ARCHITECT'S SUPPLEMENTAL INSTRUCTIONS

PROJECT:	The Reserves at Magnolia New Apartment Complex Denton, TX	Report No.	One (1)
OWNER:	Overland Property Group Dan Maximuk 234 N. Santa Fe Ave, Suite A Salina, KS 67401	Date	Oct. 22, 2024
CONTRACTOR:	Snyder Construction Group 4820 N. Town Centre Dr. Ozark, MO 65721	Architect's Proj No.	21-3205
		Contract For:	General Construction Mechanical, Electrical

Please Note: Drawings and Specification Edits associated with this ASI are dated as **7-17-2024**. This date above is the date this ASI was issued.

3 ALT. ONE BEDROOM DOMESTIC WATER RISER DIAGRAM
Not to Scale
REFERENCE P4 SHEETS FOR EXACT FIXTURE TYPES

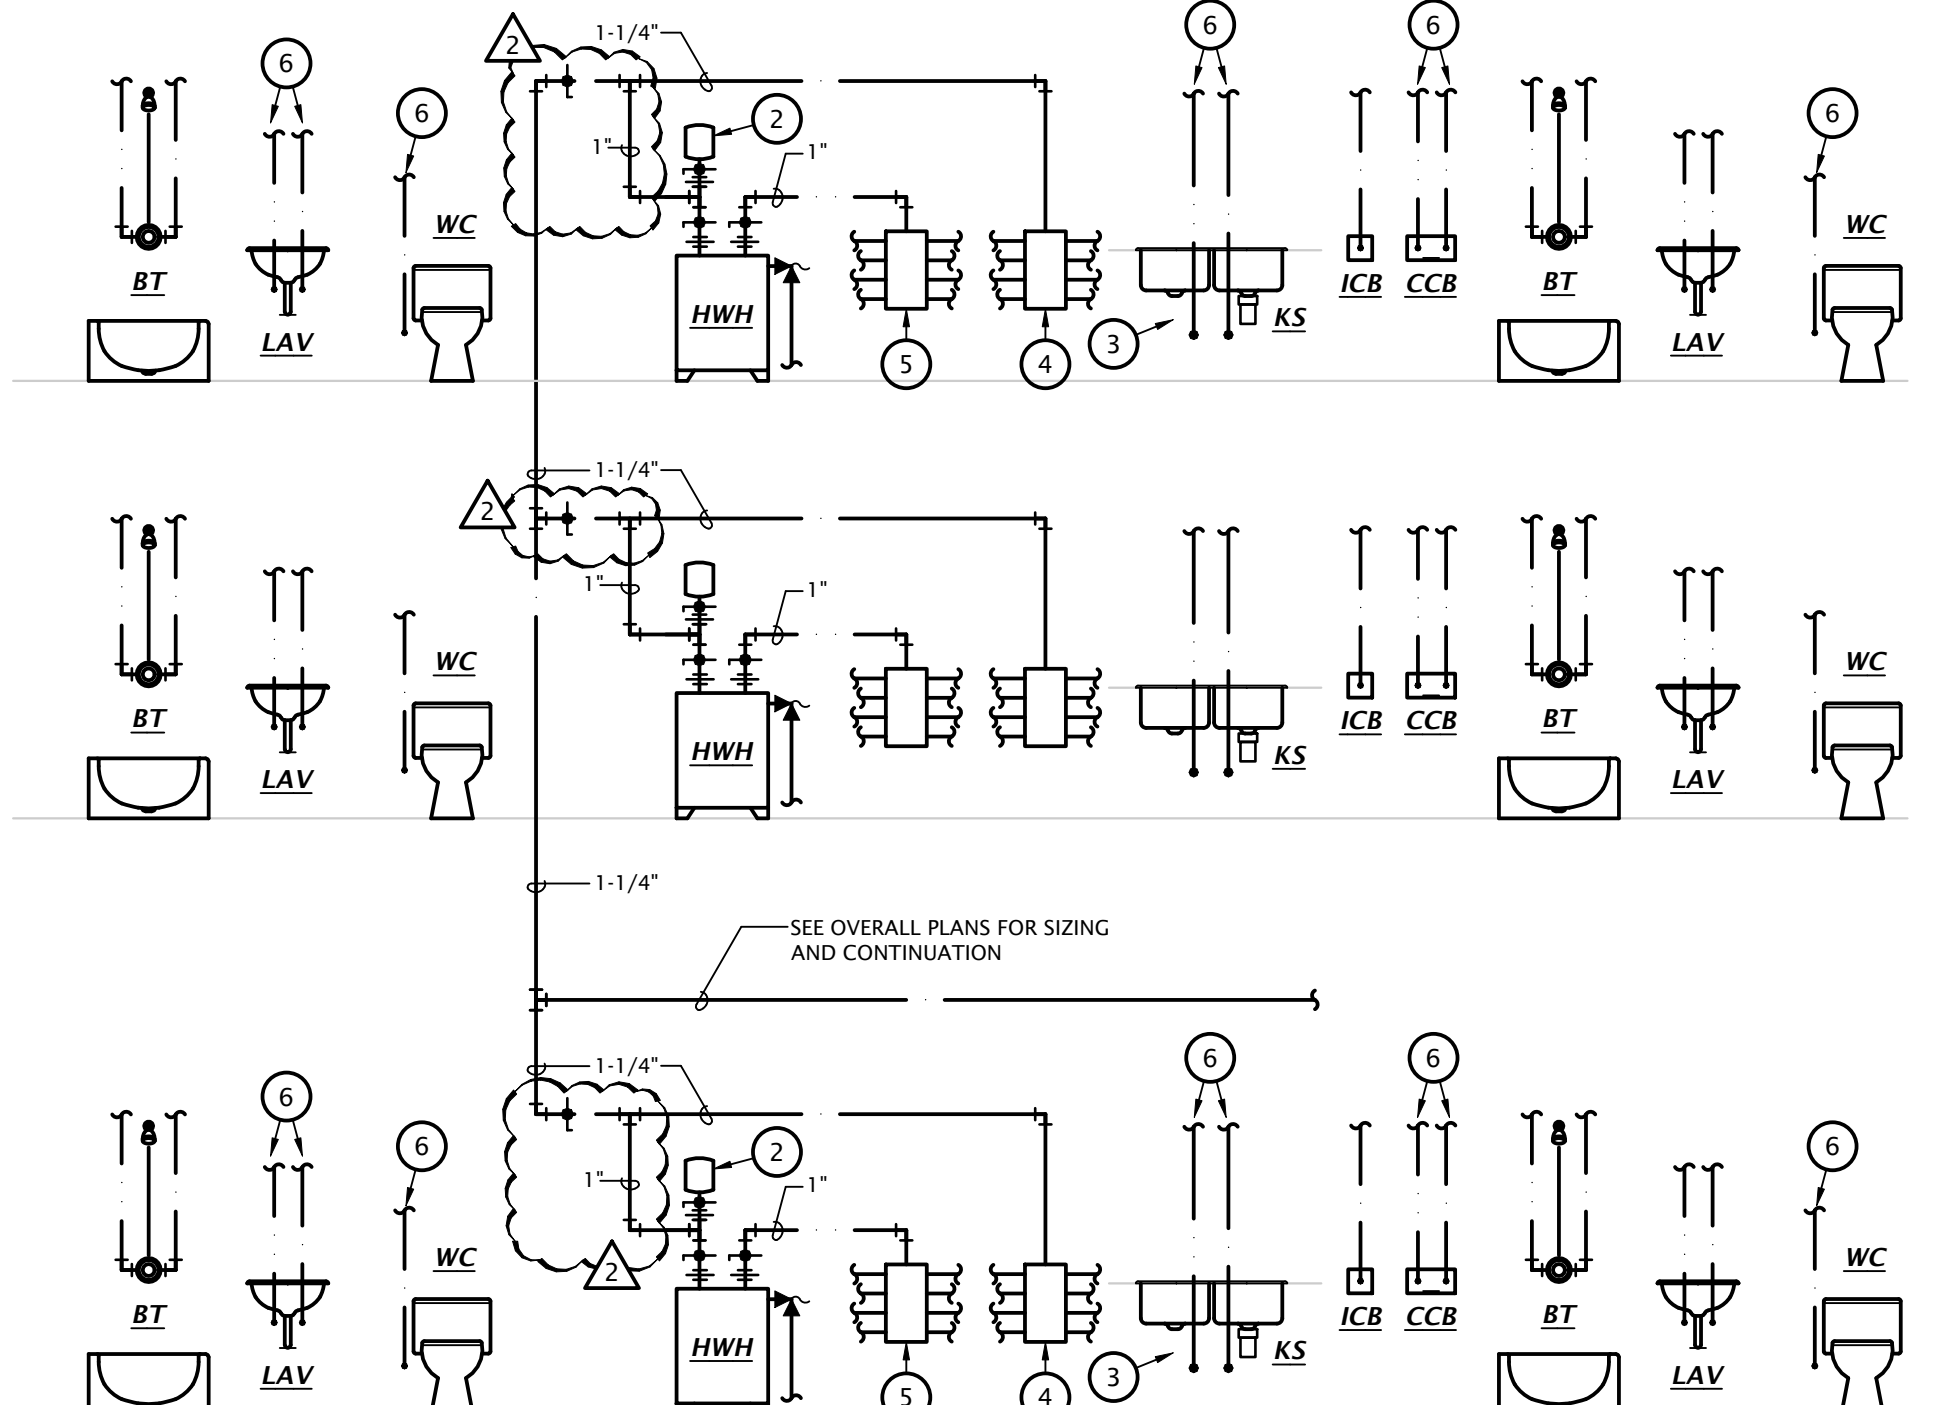
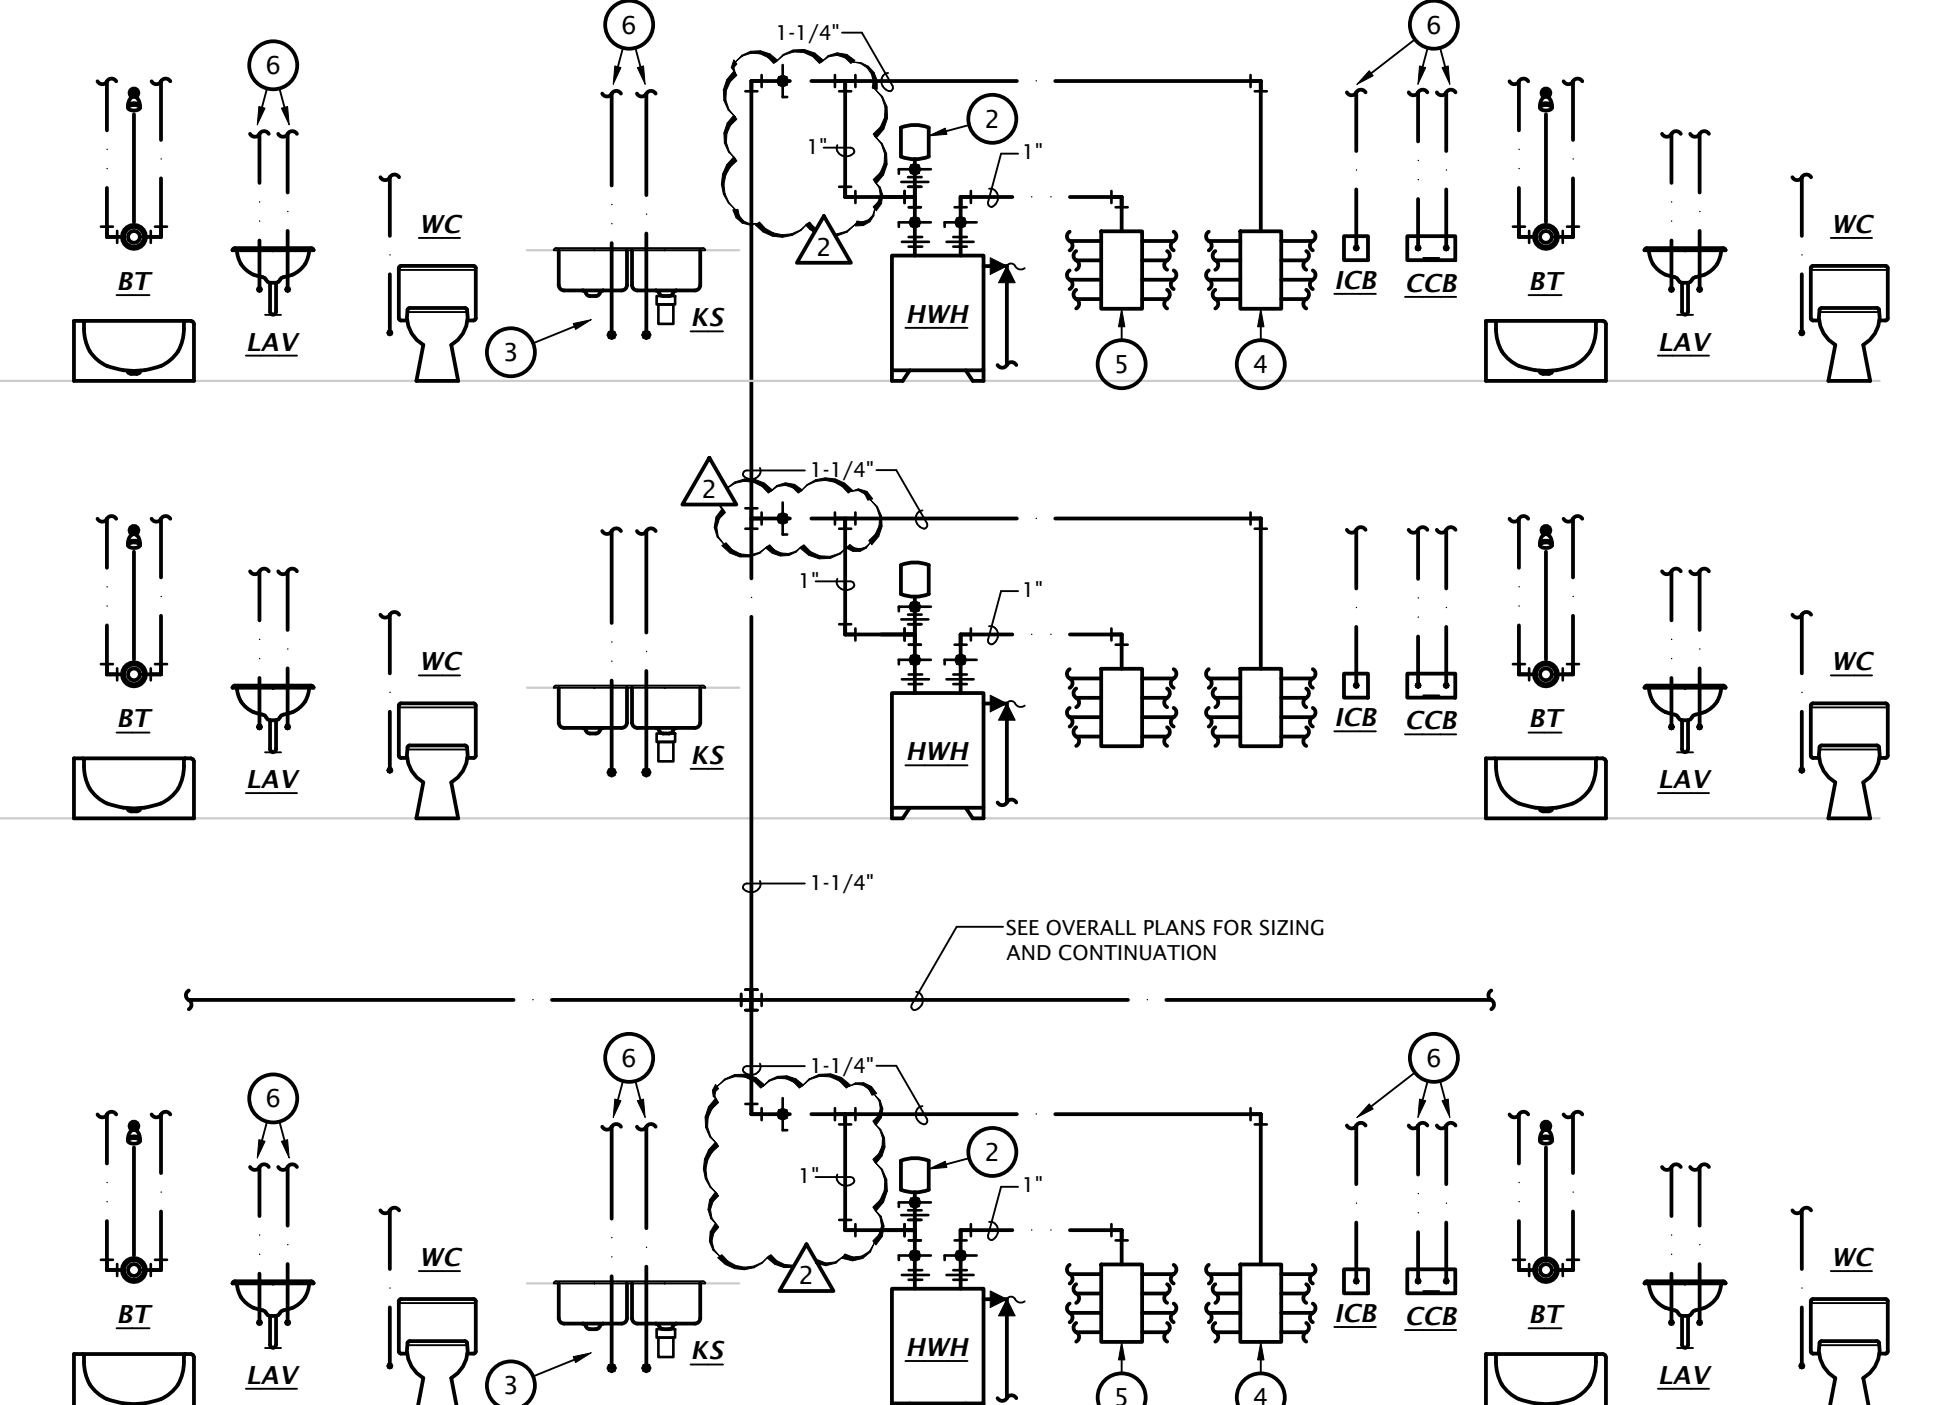
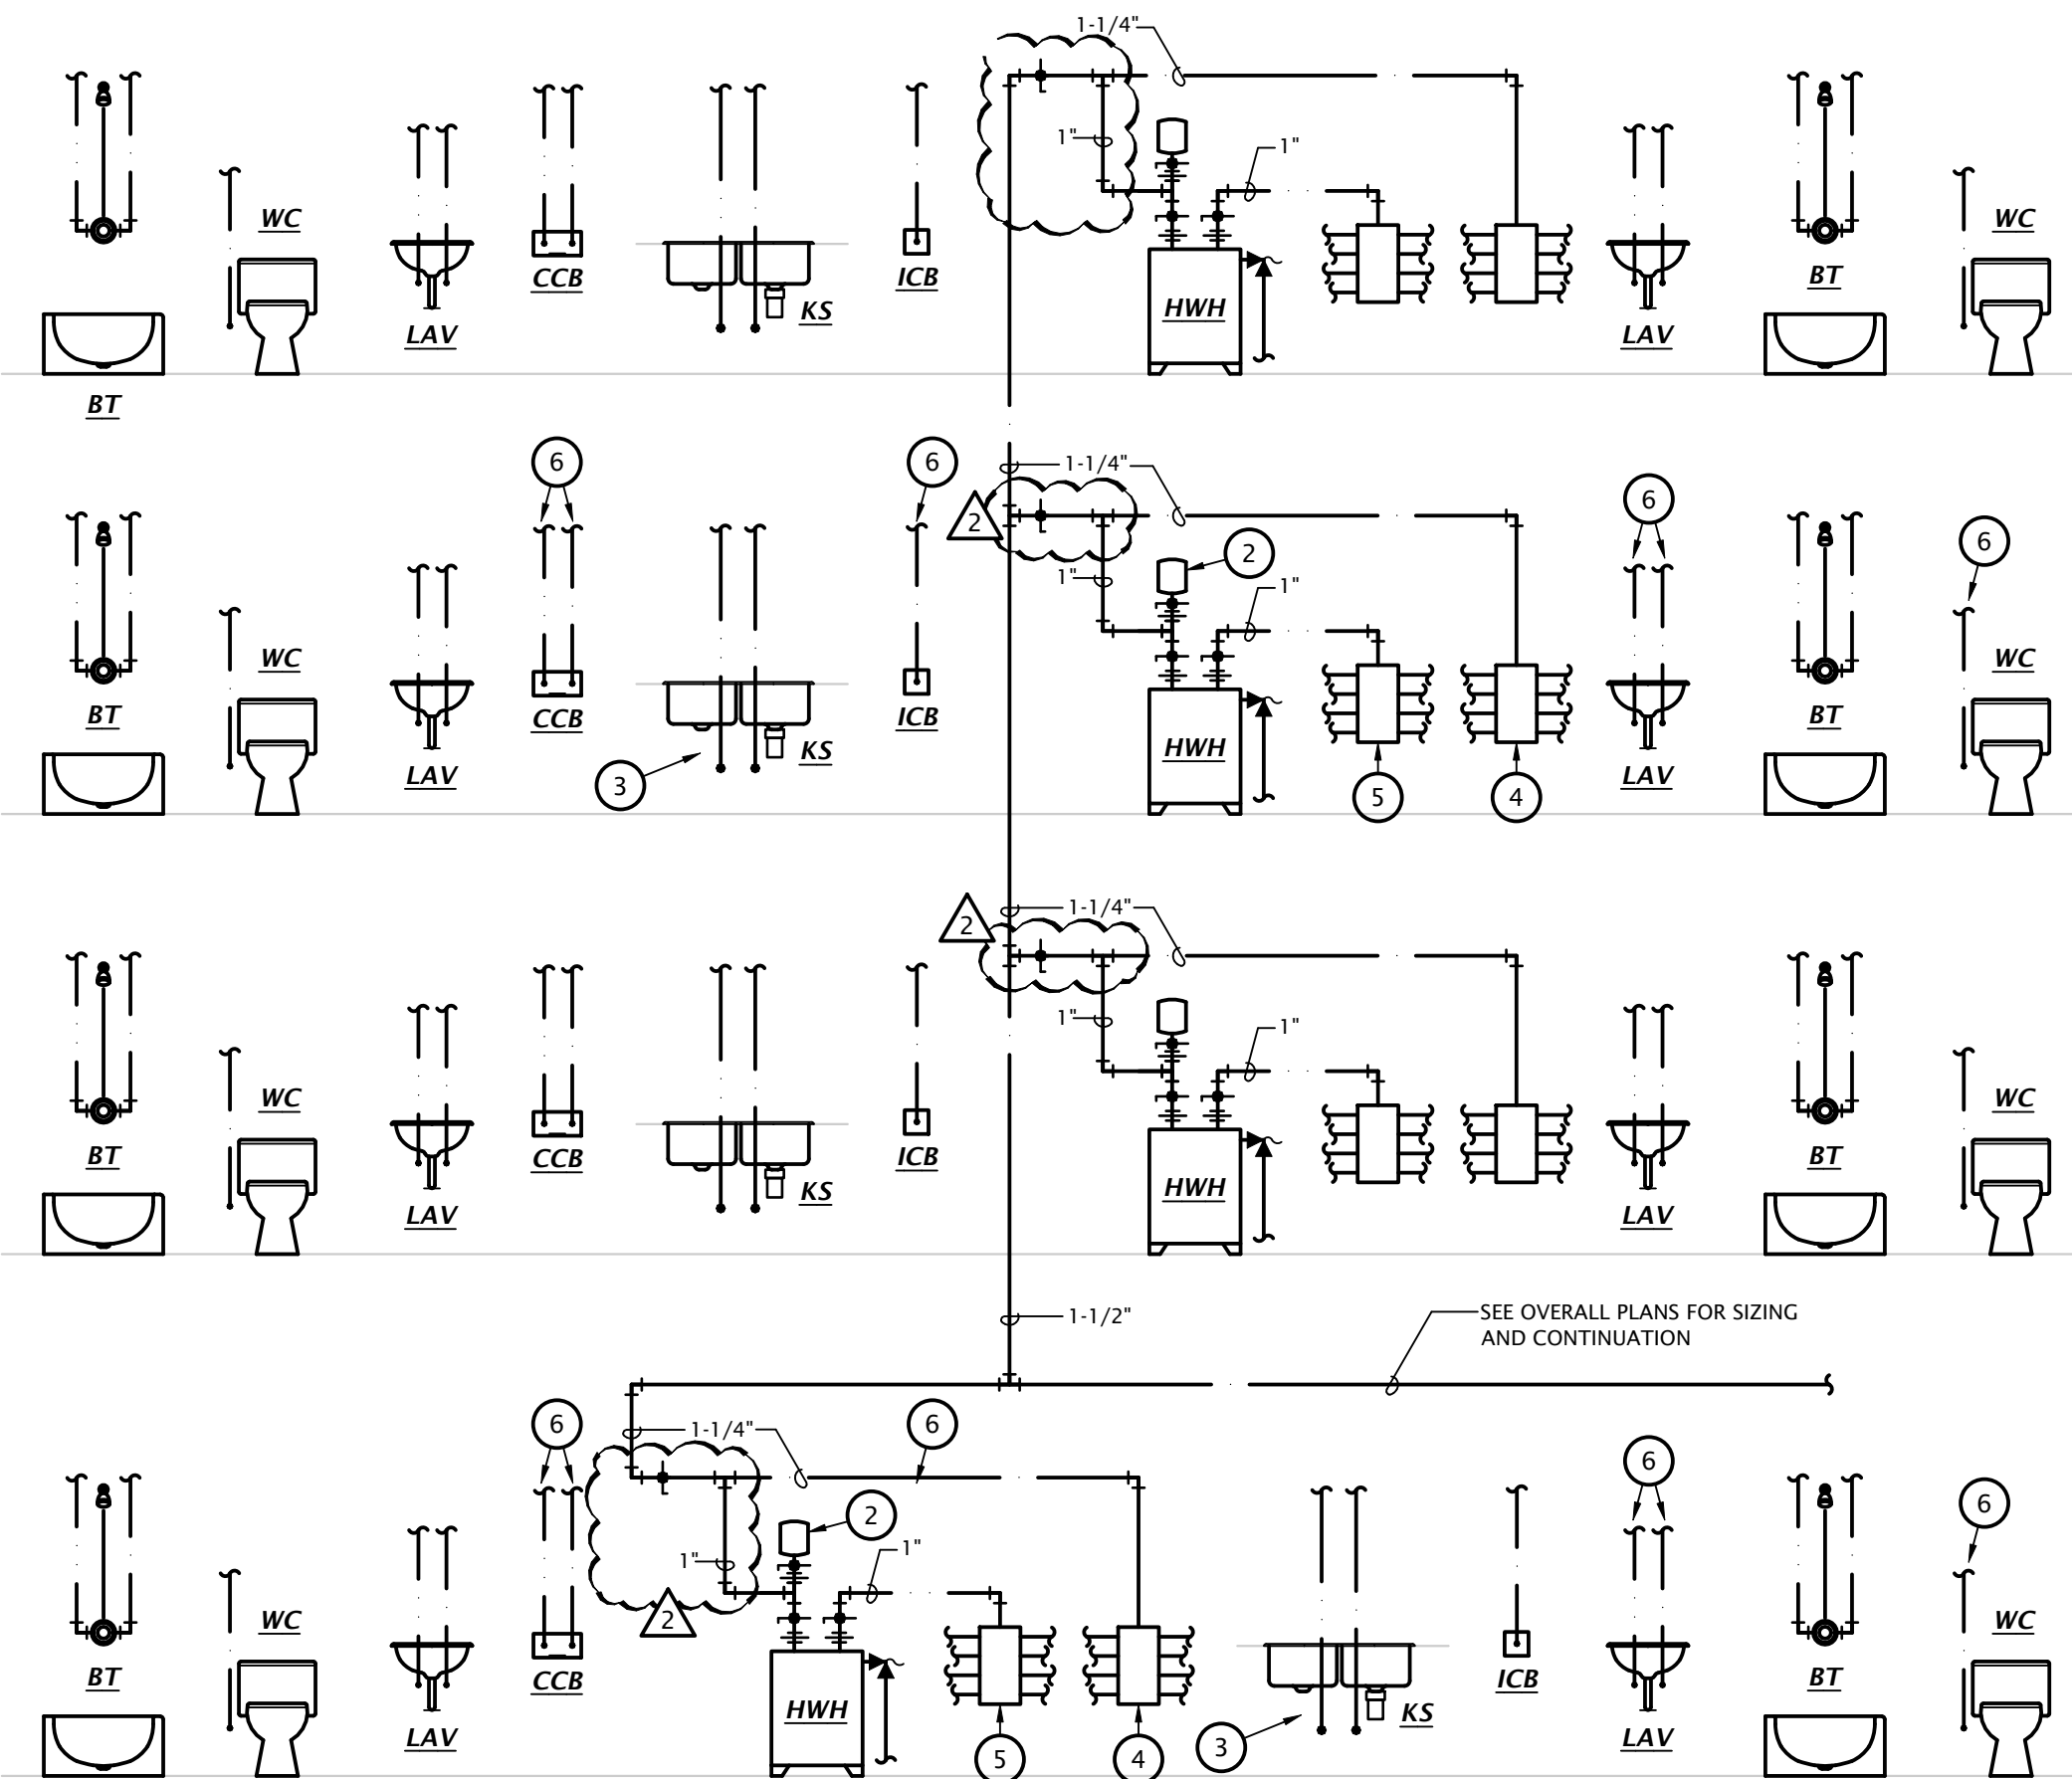
- 27) Utilize a Watts model PLT-5 or equal expansion tank at HWH-A water heaters in lieu of the specified Watts Model DETA-12 expansion tanks. (VE Item #32) Reference revised Sheet P6.1

1. NOT USED.
2. PROVIDE WATTS MODEL PLT-5 EXPANSION TANK. (TYPICAL)
3. PROVIDE 1/2" VALVED HOT WATER CONNECTION TO DISHWASHER. (TYPICAL)
4. COLD WATER SUPPLY PEX MANIFOLD. (TYPICAL)
5. HOW WATER SUPPLY PEX MANIFOLD. (TYPICAL)
6. ROUTE HOT AND COLD WATER PEX AS REQUIRED FROM FIXTURE TO APPROPRIATE MANIFOLD. SEE P4 SHEETS FOR SIZING AND CONTINUATION. (TYPICAL)
